1. Type of Well		4:	8. Well Name a	
2. Name of Operator		ESLIE M GARVIS	19. API Well No	
BURNETT OIL CO., INC.	E-Mail: lgarvis@bur	nettoil.com	30-015-34	
3a. Address BURNETT PLAZA - STUITE FORT WORTH, TX 76102	1500 801 CHERRY STREE	3b. Phone No. (include area code) EPh: UNIFORE 5/VOFEM; 63/26	76102 10. Field and P	ool, or Exploratory AKE GLORIETA YESO

DRILLING PLAN Stevens A 12 Deepening

Stevens A 12 30-015-34225 Burnet Oil Co. March 28, 2014 Conditions of Approval

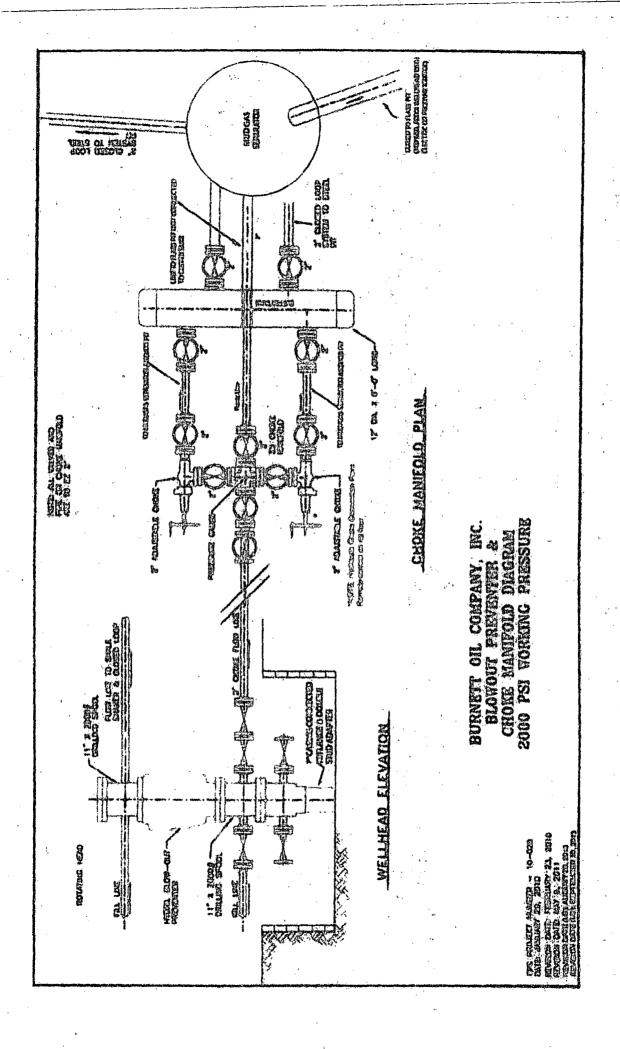
- 5. BOP to be tested to 2000 psi based on BHP expected. In the case where the only BOP installed is an annular preventer, it shall be tested to a minimum of 2000 psi (which may require upgrading to 3M or 5M annular).

- 6. Variance for stand-off of less than 0.422" is approved due to NMOCD classifying the formations in this area as the Yeso group.
- 7. Cement on liner shall tie back to liner top, if this is not achieved contact appropriate BLM office. When plugged, cement plug will be required across this tie back and across squeezed perforations.
